## Muting circuit change

**PROBLEM:** Popping noise at pre out and speaker out during turn on and off.

**CAUSE:** Muting circuits response is slow.

**SECTION C- MULTI CHANNEL BOARD. (SEE SCHEMATIC)**

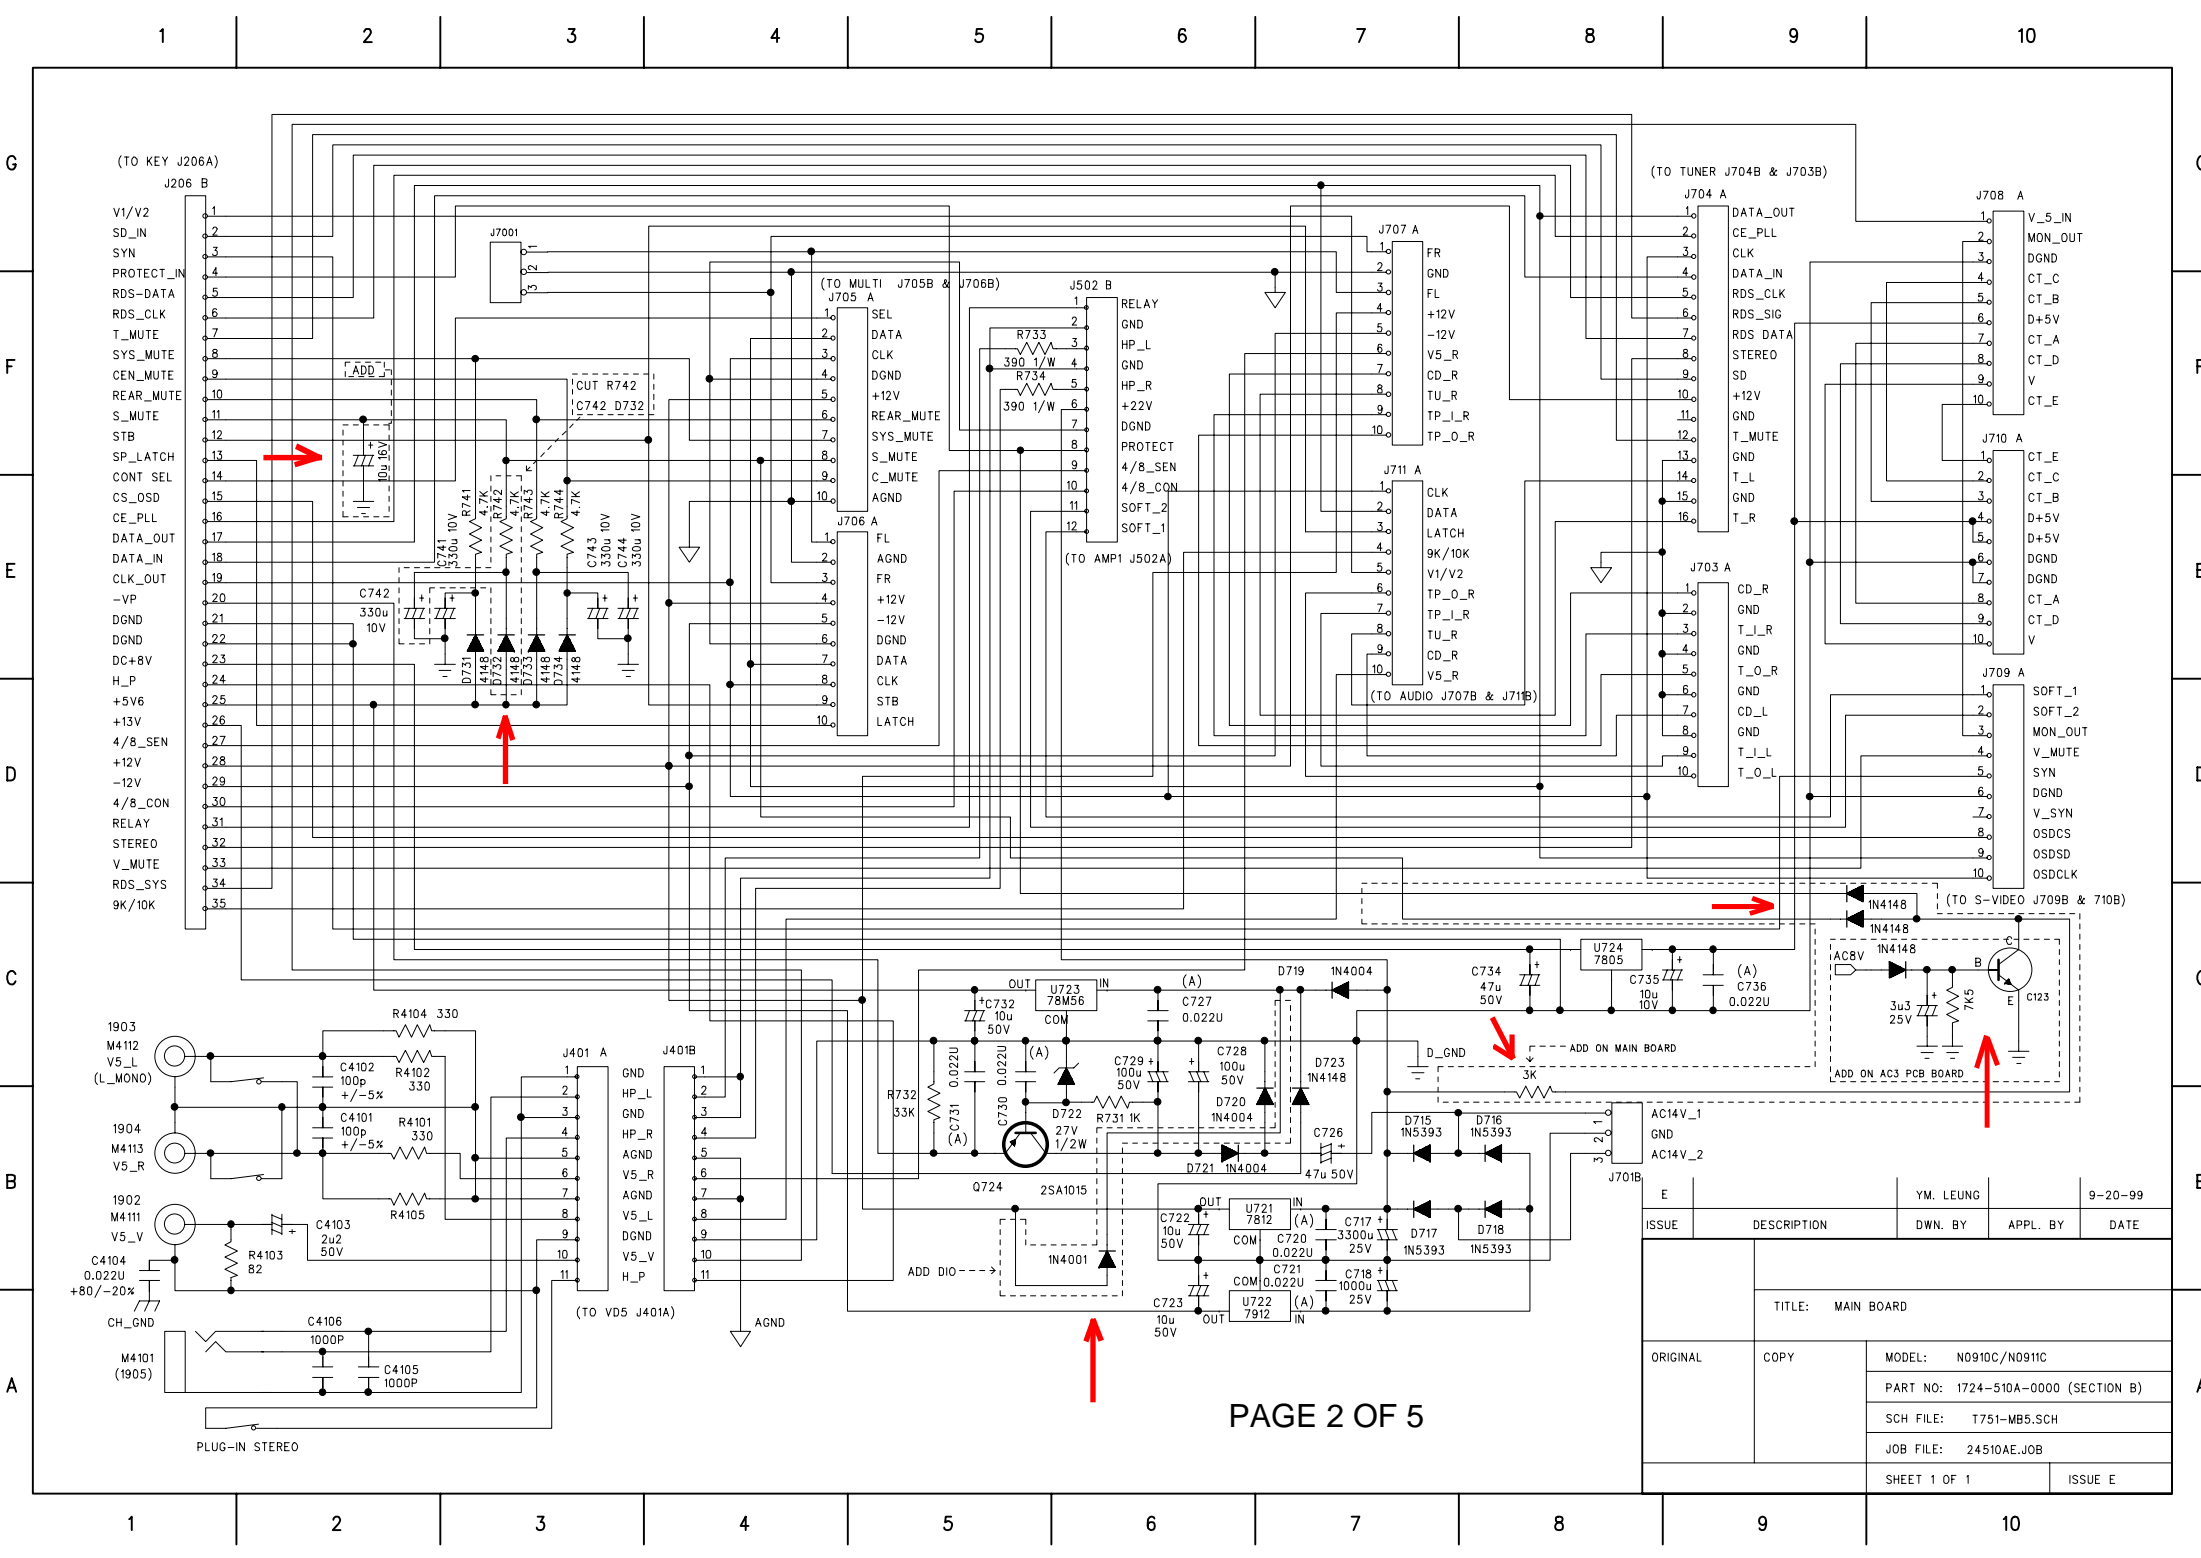
1. DELETE R665(10K)
  2. CHANGE Q605 FROM RN1241 TO 2SC2878.
-

ISSUE	DESCRIPTION	YM. LEUNG	DWN. BY	APPL. BY	DATE
	TITLE: MAIN BOARD				
ORIGINAL	COPY	MODEL: N0910C/N0911C			
		PART NO: 1724-510A-0000 (SECTION B)			
		SCH FILE: T751-MB5.SCH			
		JOB FILE: 24510AE.JOB			
		SHEET 1 OF 1		ISSUE E

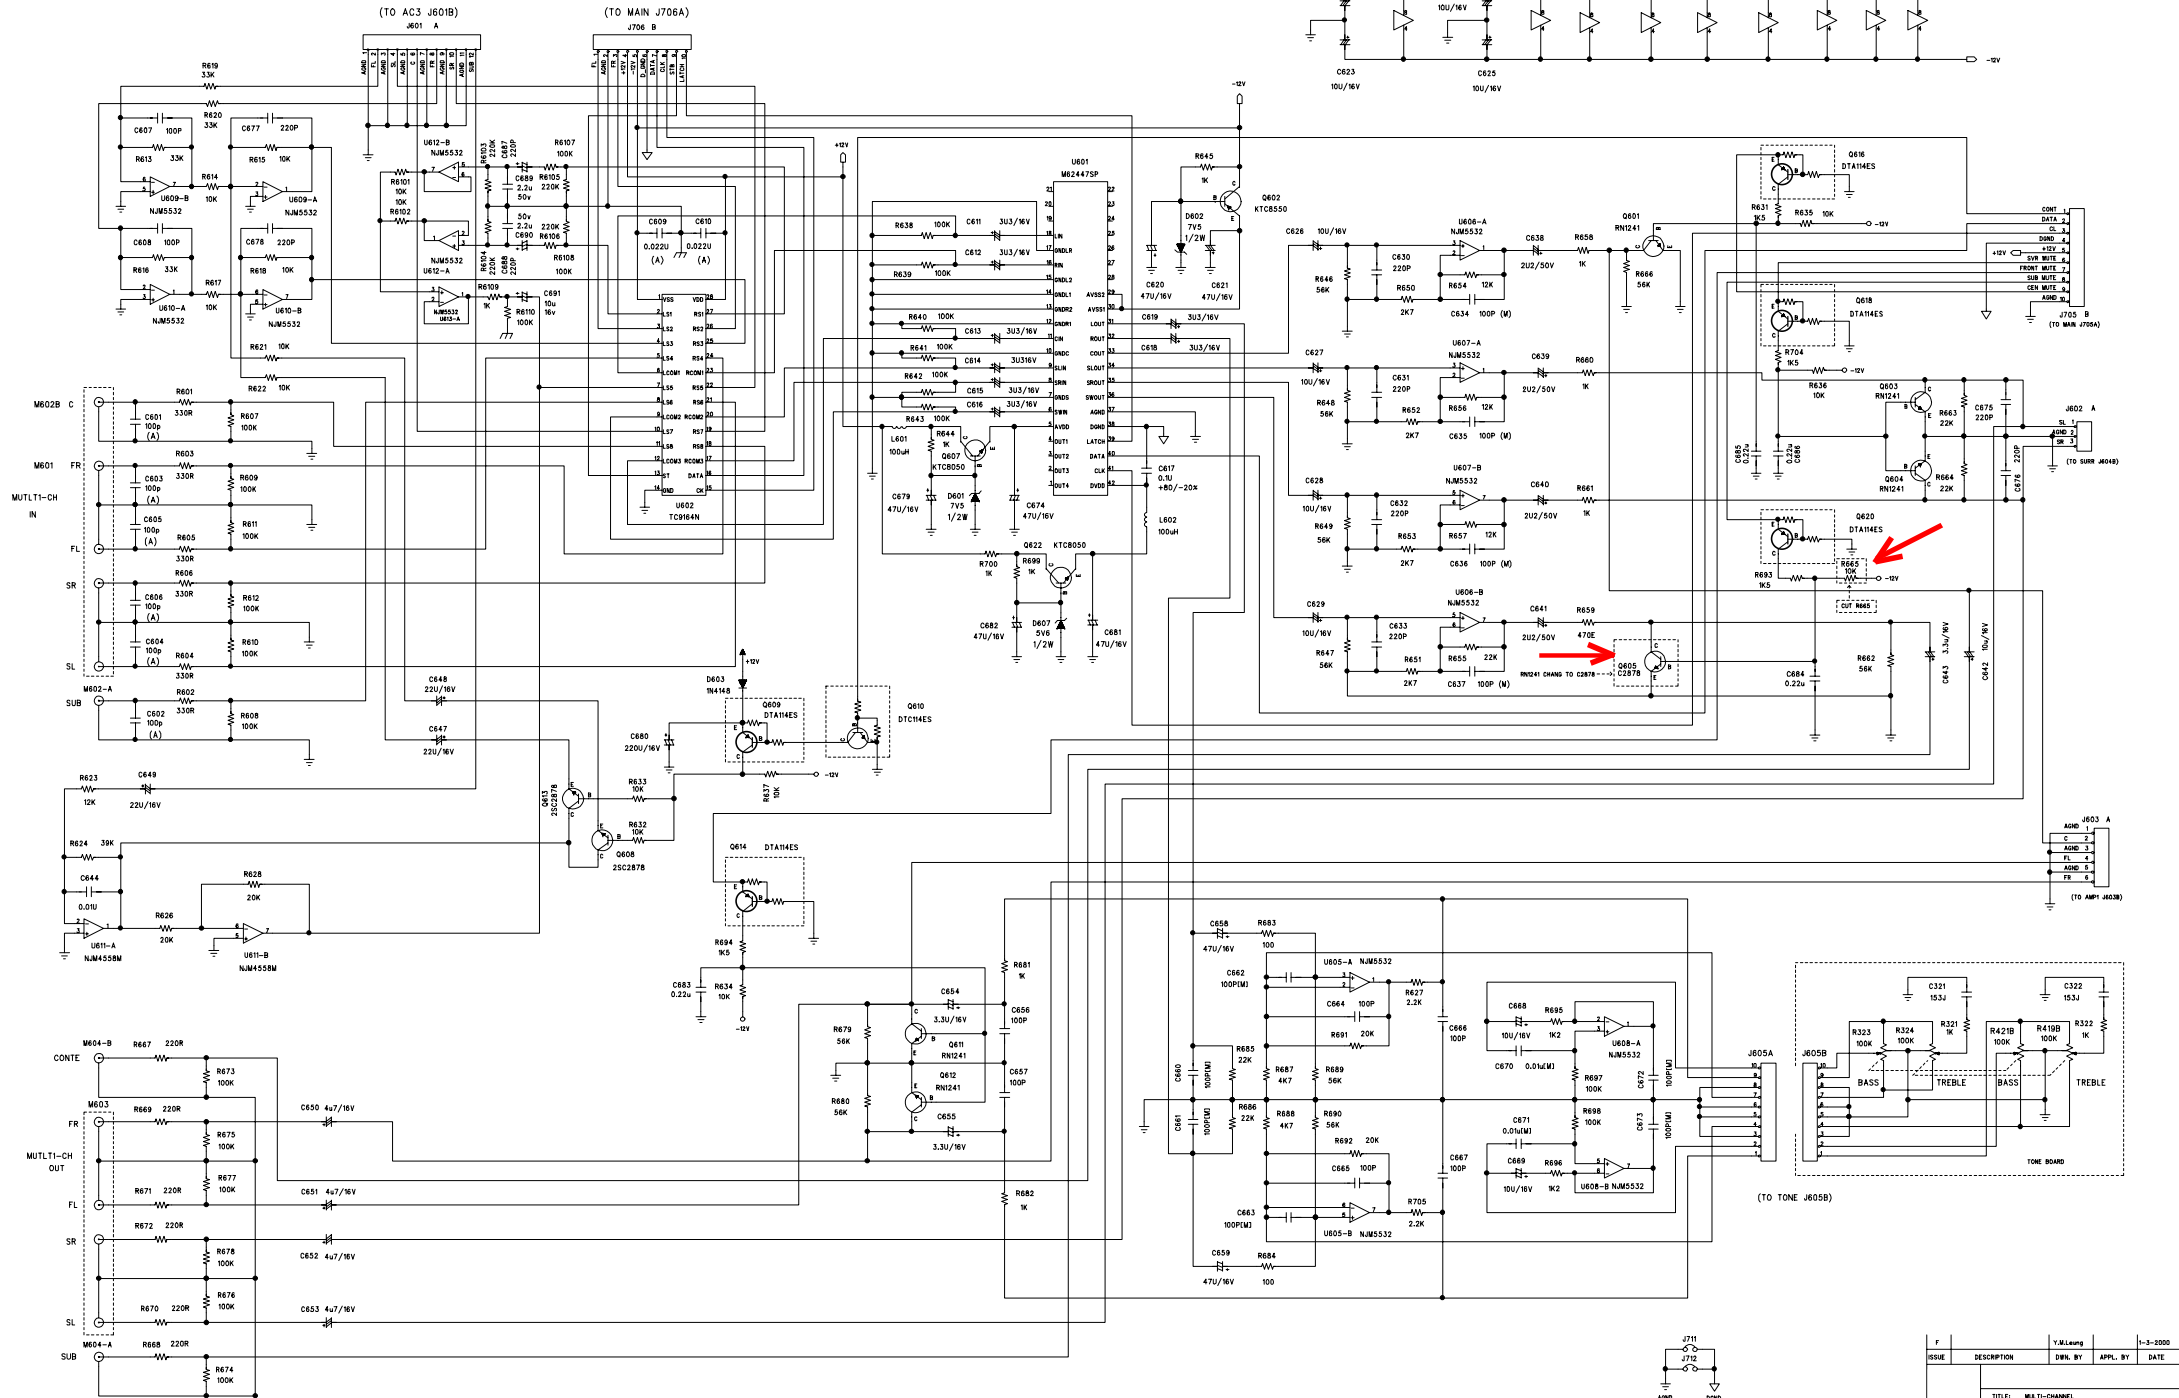
**SECTION B - MAIN BOARD**

1. DELETE R742(4K7) D732 (1N4148) AND C742 (330Uf/10v)
2. ADD 2 PCS OF 1N4148 DIODE .
3. ADD 10uF /16V ELECTROLYTIC CAPACITOR
4. ADD 3K 1/8W RESISTOR
5. ADD 1N4001 DIODE

ORIGINAL	COPY	MODEL: N090C / N091C
		PART NO: 1724-920A-000 (SECTION A)
		SCH FILE: 178M101SCH
		JOB FILE: 24520AEJOB
		SHEET 1 OF 1
		ISSUE F

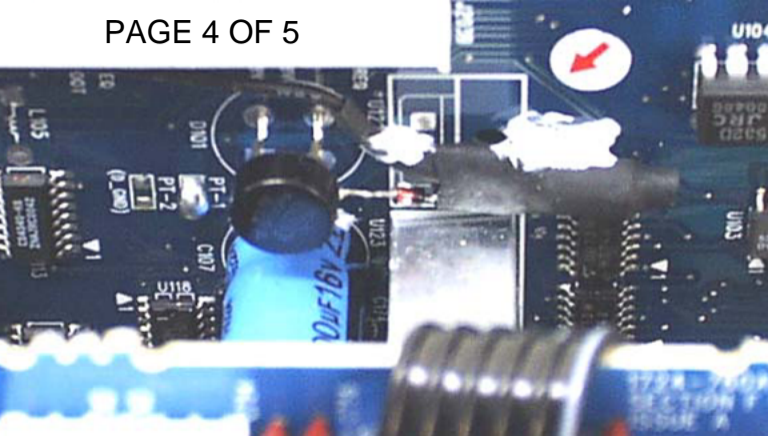
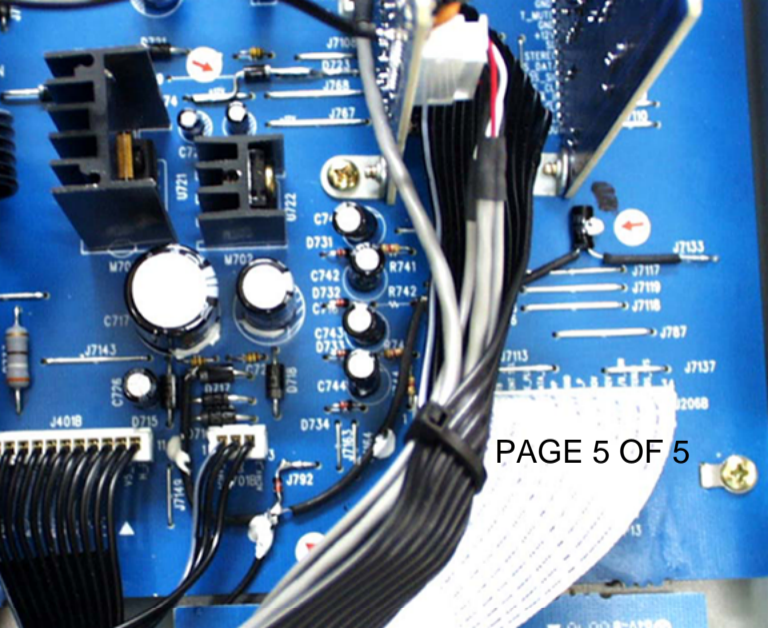
Components are to be placed in a shrinkable tube and the whole thing is glued to the AC-3 board. See attached photo and schematic diagram.

**SECTION A - AC-3 BOARD**

1. ADD 2SC123 TRANSISTOR
2. ADD 3.3uF/25V CAPACITOR
3. ADD 7.5K 1/8W RESISTOR
4. ADD 1N4148 DIODE
